RE: Hogan's Fountain Teepee Pavilion, Cherokee Park

Re. Cherokee Park Hogan's Fountain Pavilion

Subject: Cherokee Park, Hogan's Fountain Teepee Pavilion Reassessment

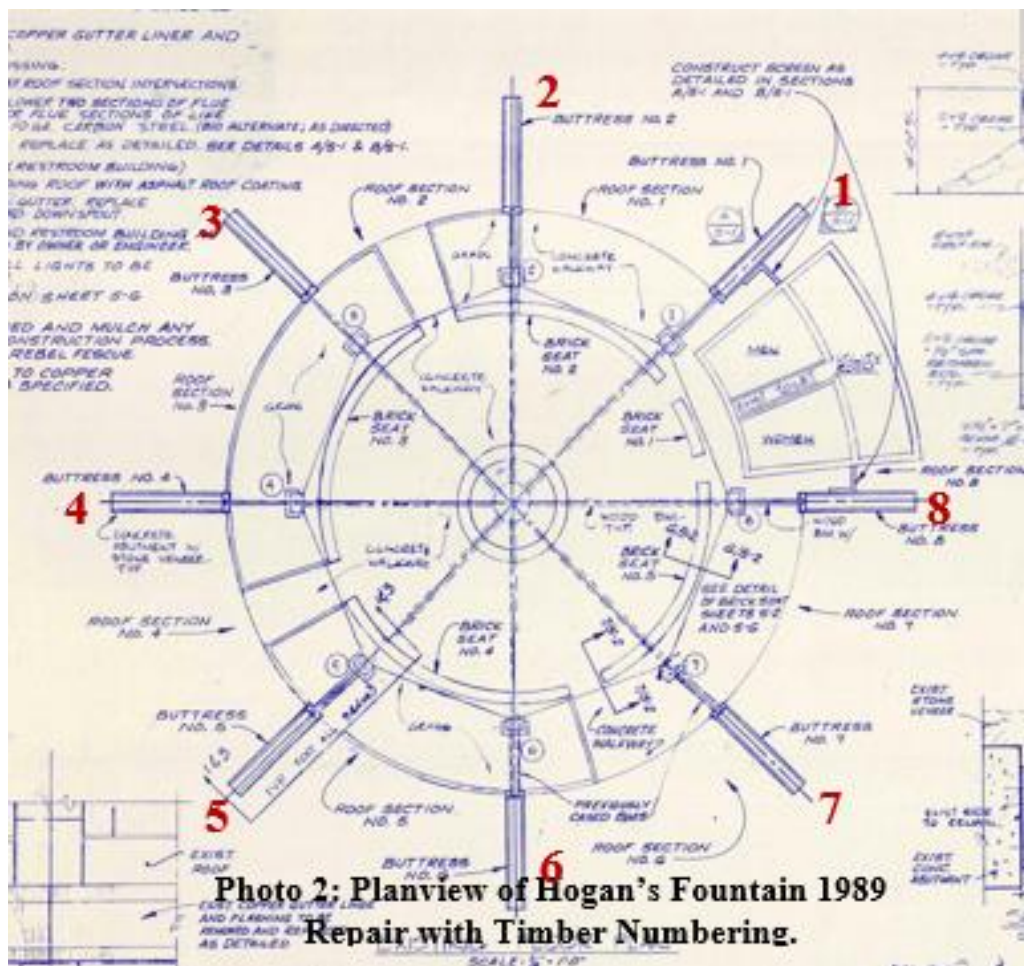
throughout. Due to the recent movement of the structural timbers, Wood was requested to evaluate the condition of the encased timbers and to determine if the timbers have experienced deterioration. Wood hired subcontractor, Concrete Coring & Cutting, to drill 2-inch diameter holes in the $\frac{1}{2}$ -inch steel casing to evaluate the wood condition. The following provides a brief overview of our results. For this evaluation, Wood used the same naming nomenclature used on the 1989 plans.

Based on our evaluation, the wood encased in the steel has experienced severe deterioration and therefore is not structurally sound. Repair options should not utilize this section of wood as a structural component. In addition, in several areas, the wood above the steel is showing signs of distress (delamination, darkening of the wood from possible water damage, etc.).

Photo 3: Steel Casing Access Hole at Location #1

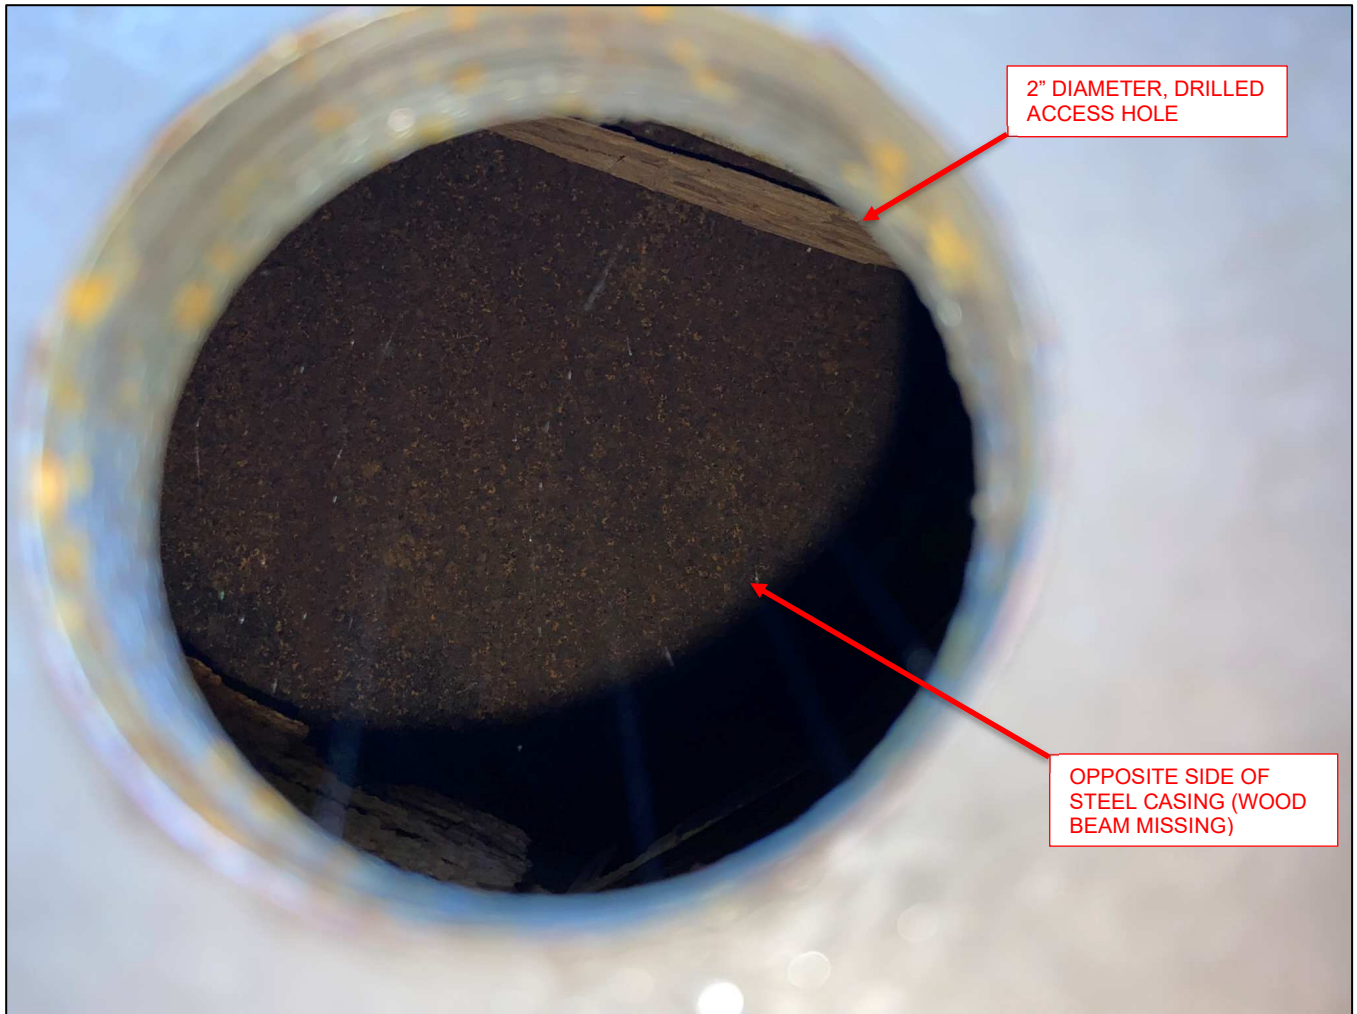
- Wood beams within the mid-section of the steel casings at locations 1, 2, 3, 4, 6, 8 (**Photo 3**) have so deteriorated that there is either no wood evident, the member section is partially lost, or the wood is so soft that it does not resist probing with an ice pick.
- Wood rot has been confirmed throughout most of the steel casing length on the majority of the beams.
- The retrofitted steel dowels in the casings are no longer providing the axial, bending, and shear load transfer to the steel casing that was designed to simulate a beam extension.
- The gap at beam #6 was measured and found to be about 4 ½" which is ½" more than previously documented in May (**Photo 4**). This side of the structure appears to be lifting.
- Lifting movement from beam #6 is pulling on the exhaust hood and lifting one side as seen in **Photo 5**.
